ENGINEERING CHANGE NOTICE

Proj. ECN ER2567-1

3. Originator's Name, Organization, MSIN, and Telephone No. J.D. Axford, KEH, E6-31, 6-6071			4. Date 10/16/92	
5. Project Title/No./Work Order No. Grout Processing Support Facility Drain Field Expansion/ER3077		6. Bldg./Sys./Fac. No. MO-392		7. Impact Level 4 / SC-3

12. Description of Change  
Documents affected: ER2567-C1, Rev 0, H-2-140591, sheets 1 & 2, Rev 0

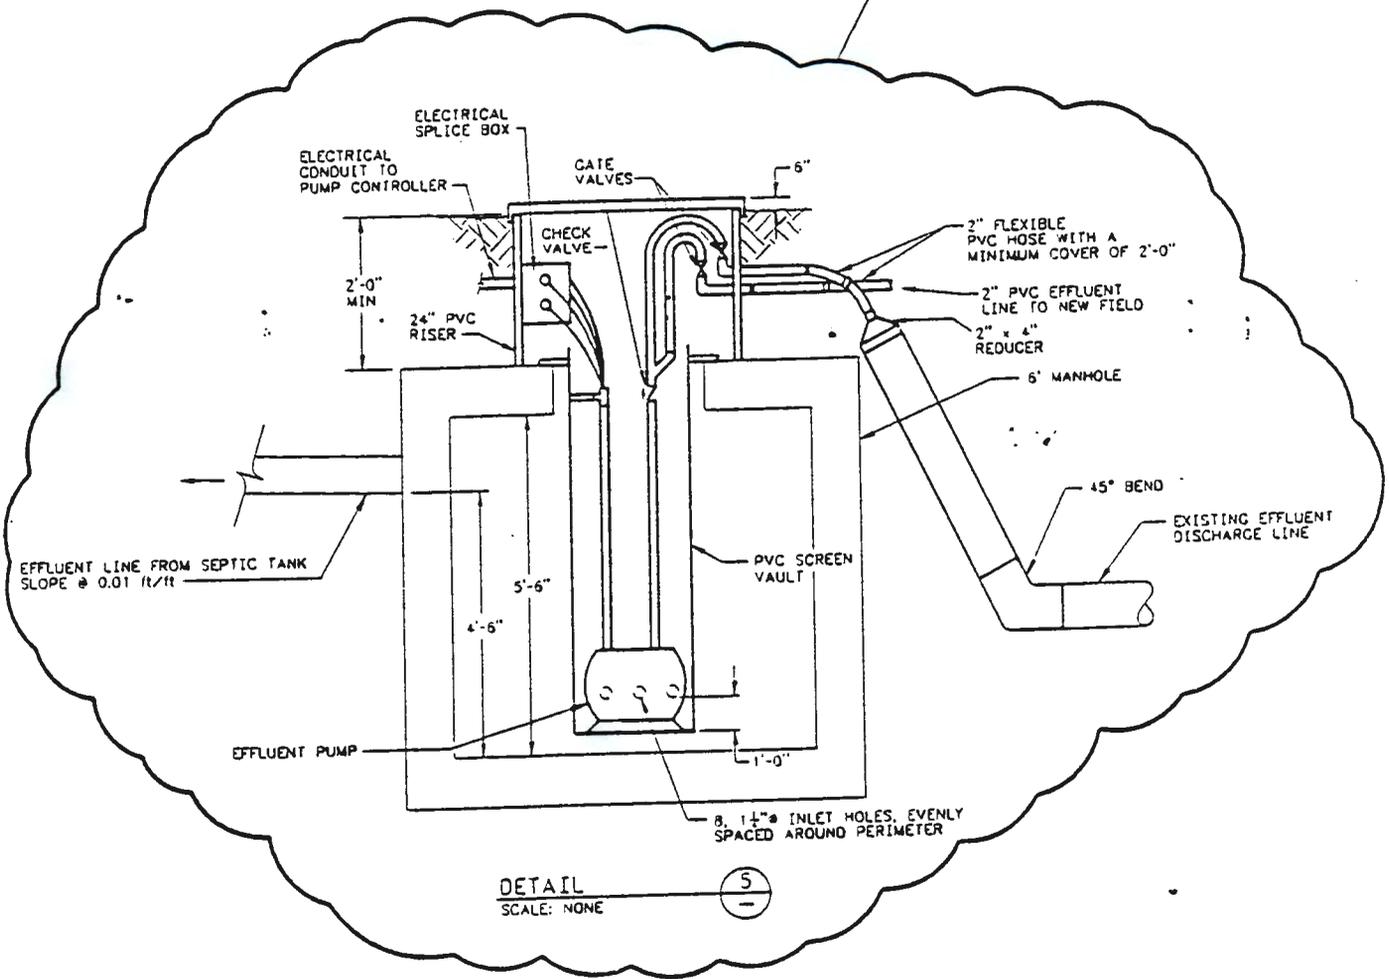
- A) 02740-1.1.1.4: Add: M-21-01-92, Standard Plans for Road, Bridge, and Municipal Construction.
- B) 01010-1.2.2.1 Change: '3' to '4.'
- C) 01010-1.2.2.5 Revise to read: Furnish and install pump chamber, pump, and pump control panel.

- D) 01010-1.3 revise section as follows:
- 1.3.1.1 Install new drainfield, pressure line and pump chamber; install pump alarm/control panel, and level operating switches; connect power supply.

- 1.3.1.2 Empty (see subparagraph 1.2.3.1) the second tank and modify the existing effluent line as shown on the Drawings.
- 1.3.1.3 Perform final system tests.

- E) Delete 01010-1.3.1.4 and 1.3.1.5
- F) Add: 02740-2.2.5.6: Pumping Chamber: 72" DIA manhole as per WSDOT M21-01 Standard Plan B-23c, with the accessway modified as shown in the Drawings, and without the access ladder.

- G) 02740-3.1.5 Revise to read as follows: Place pumping chamber and install screen. . . . Off Switch shall be set 2 inches above the PVC vault inlet holes, with the On and Alarm switches 21 and 24 inches above the Off switch, respectively.

- H) 02740-3.1.7.3: Revise to read: Backfill pumping chamber, septic . . . . Add Sentence: WDOH shall inspect the absorption trenches prior to backfill. Inspection shall be scheduled a minimum of five working days in advance.

- I) 02740-2.1.5: revise to read: . . .weighing 4 oz/sq yd or less.
- J) 02740-1.2: Add sentence: Submit 6 copies of each required submittal.
- K) 02740-2.2.5.2: revise to read: Pump shall be a 1/2 hp, 115 volt submersible effluent pump providing 40-100 gpm at 5-22 feet TDH. A check valve and 2 gate valves shall be incorporated in the discharge lines as shown on the drawings. A representative item is Orenco Systems Inc. Model WE05H. Pump shall be fitted. . .

- L) 02740-3.1.1.4 Revise to read: Excavate for new pressure line and absorption trenches. Make excavations to line and grade shown on the Drawings and wide enough to make connections. Store and maintain materials in manner preventing their falling or sliding into excavation. Absorption trenches shall be inspected by KEH design engineer prior to placement of drainrock. Inspection of absorption surface shall be scheduled a minimum of 24 hours in advance.

- M) 02740-3.1.4: revise to read: Construct distribution lines to the line and grade shown on the Drawings, leveled to within 1/4" per 80'.
- N) 16400-1.2 Revise to read as follows: . . .procedures. Submit 6 copies each required submittal.

- O) 02740-2.2.5.1 Change 1-1/2-inch to 1-1/4-inch, change SV1548 to SV1560, and insert the following: . . . of the vault, one foot from the bottom. A representative. . . .

Ref. Dwg.  
H-2-140591

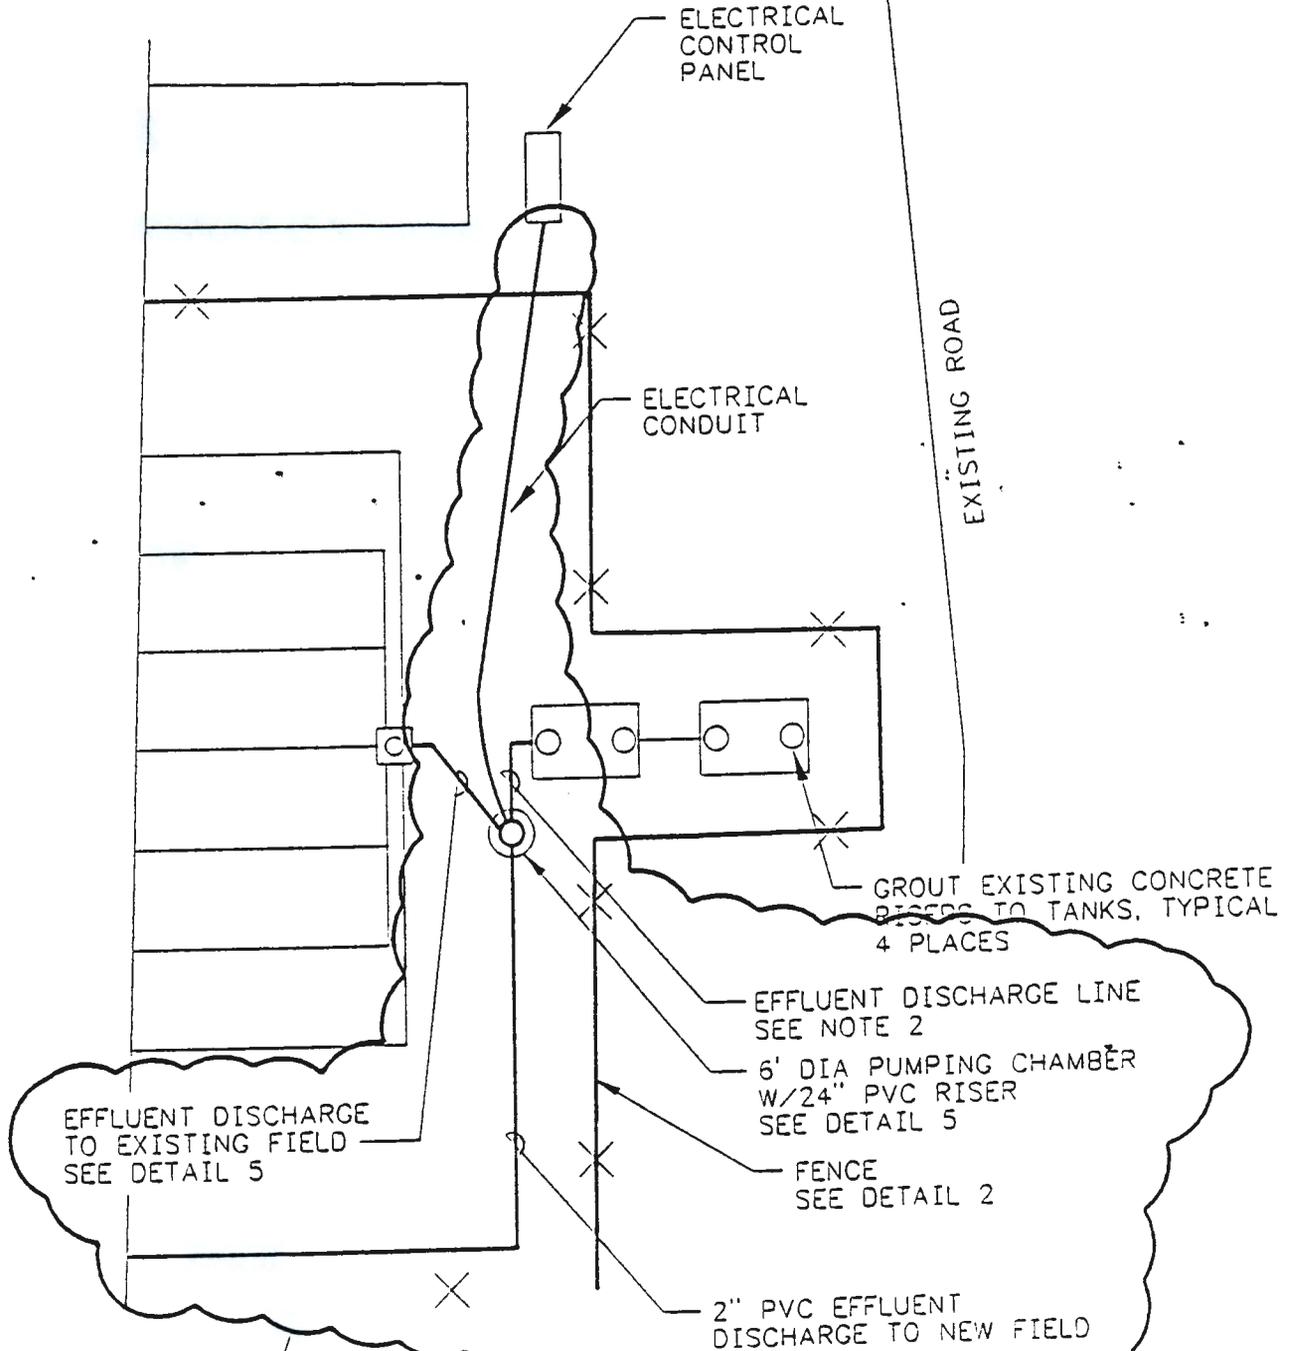
NOTES:

1. EXISTING EFFLUENT DISCHARGE LINE TO BE CUT AND REDIRECTED TO PUMPING CHAMBER. CUT AT DISTANCE FROM TANK SUFFICIENT TO INCORPORATE A 90° BEND.
2. FIELD LOCATE COMPONENTS WITHIN PVC RISER. SUBJECT TO APPROVAL OF KEH CONSTRUCTION MANAGEMENT.

ADD

ZONE D-F4

REVISE
